May 2, 2024

STRYKER LOCAL SCHOOLS
Ag Ed Addition and Courtyard Infill
Stryker, Ohio

C0-4681

ADDENDUM 3

1 COURTYARD FOUNDATION PLAN
SF101 1/8\"/>

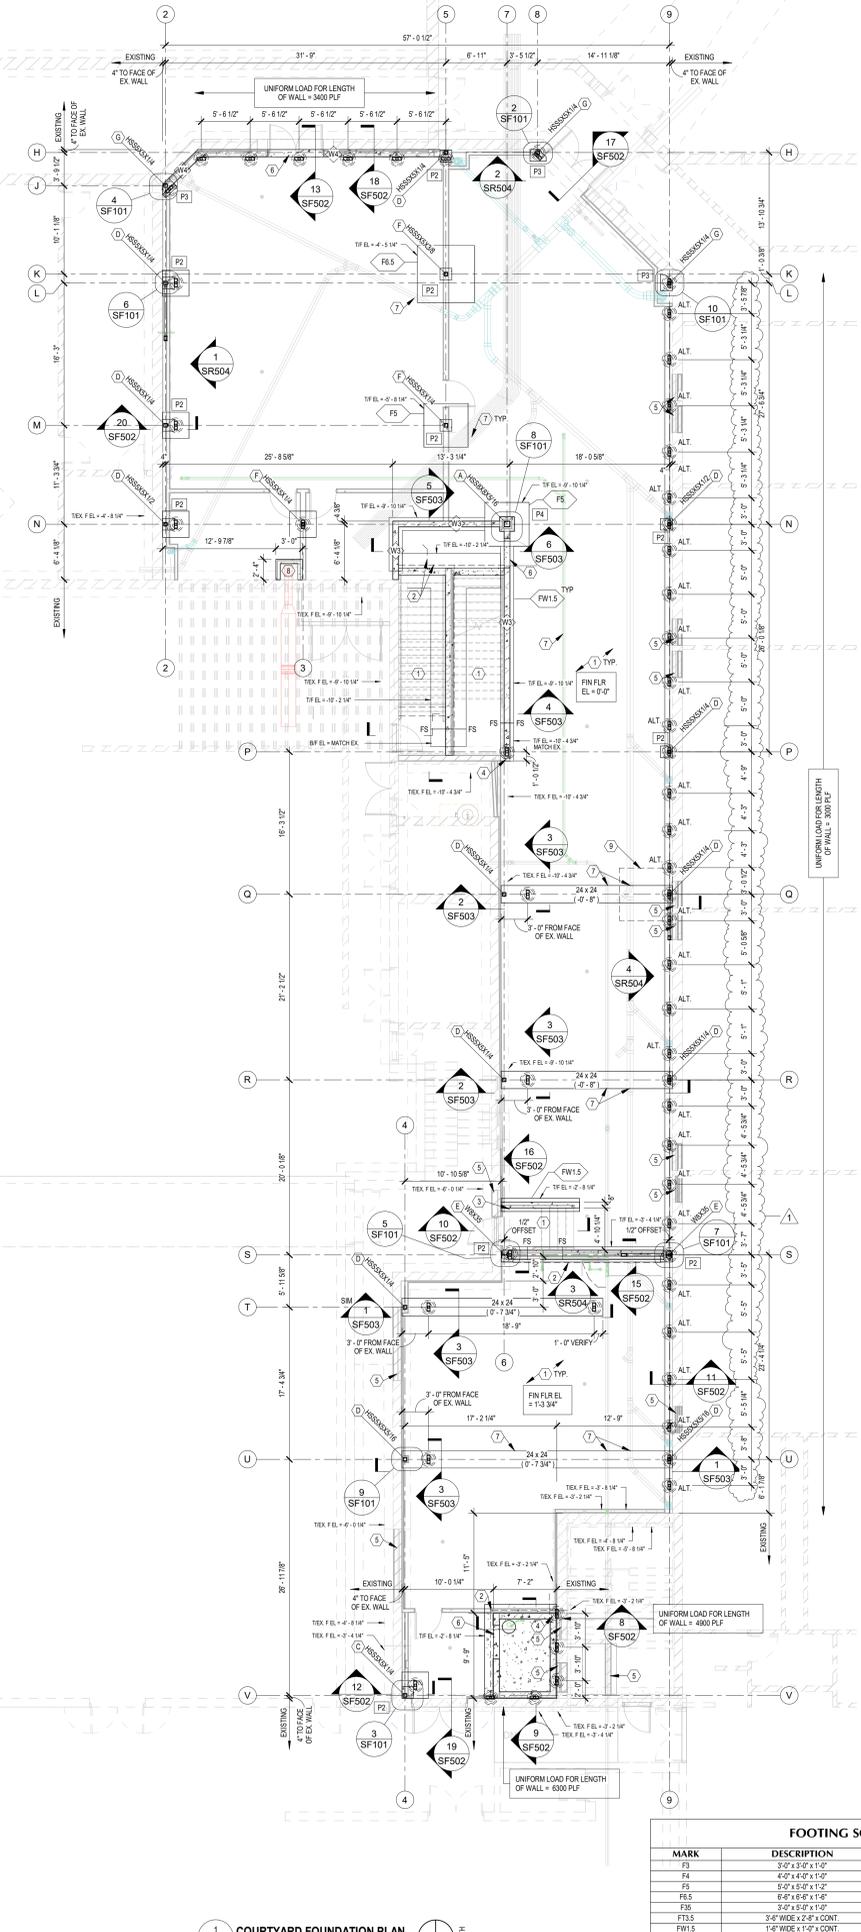
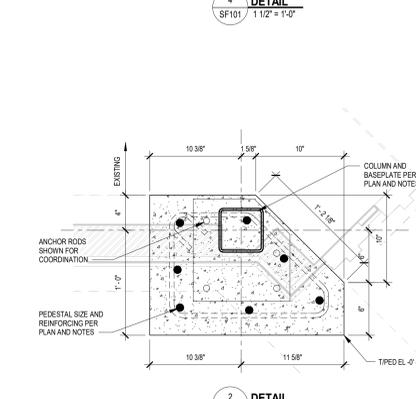
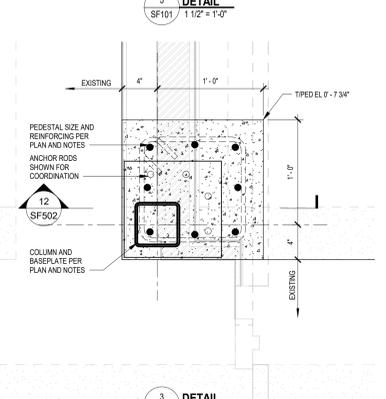
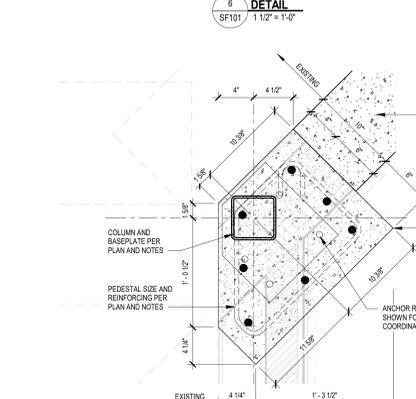
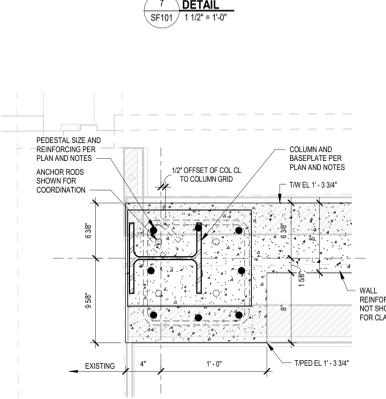
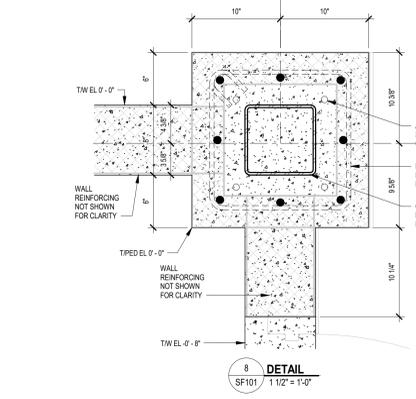
ITEM NO. 7: Sheet SF101 – Partial Foundation Plan

Refer to attached revised Drawing for helical pile layout revision. Base bid helical piles support only the new column loads; refer to revised Helical Pile Load Table which does not include wall loads. Alternate piles support only the existing wall loads.

EXTERIOR ELEVATIONS

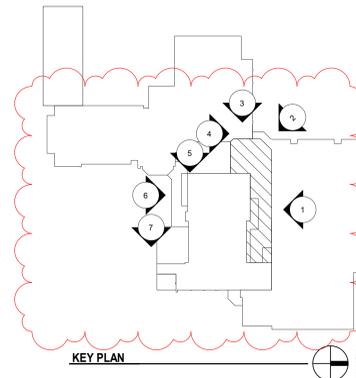
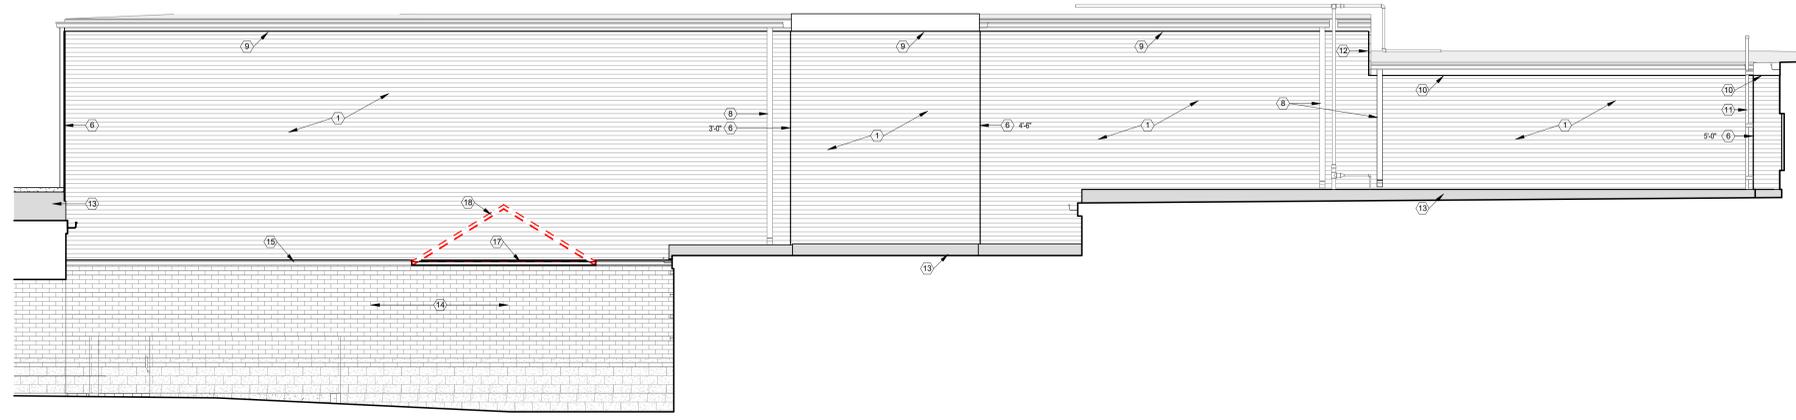
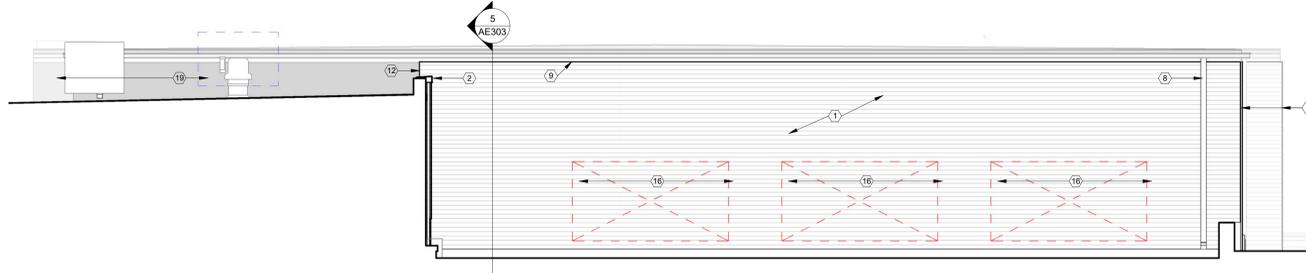
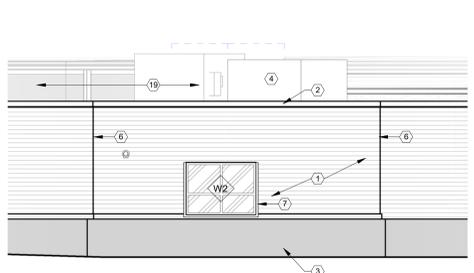
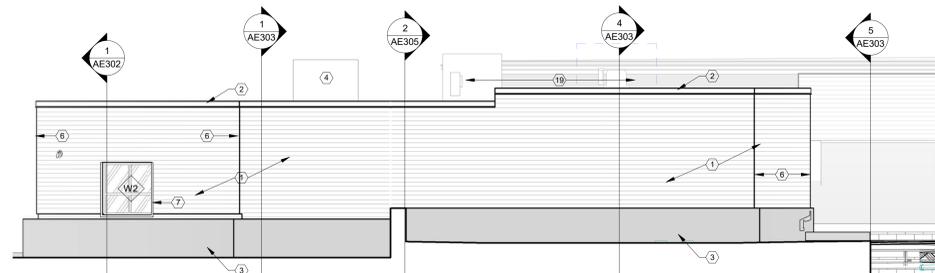
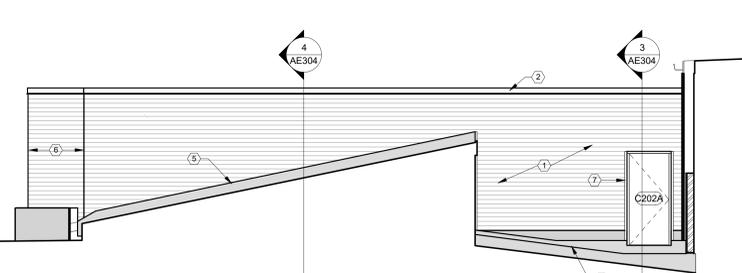
ITEM NO. 9: Sheet AE201 – Exterior Elevations

Refer to attached revised Drawing for clarification of wall panel corners and offsets.
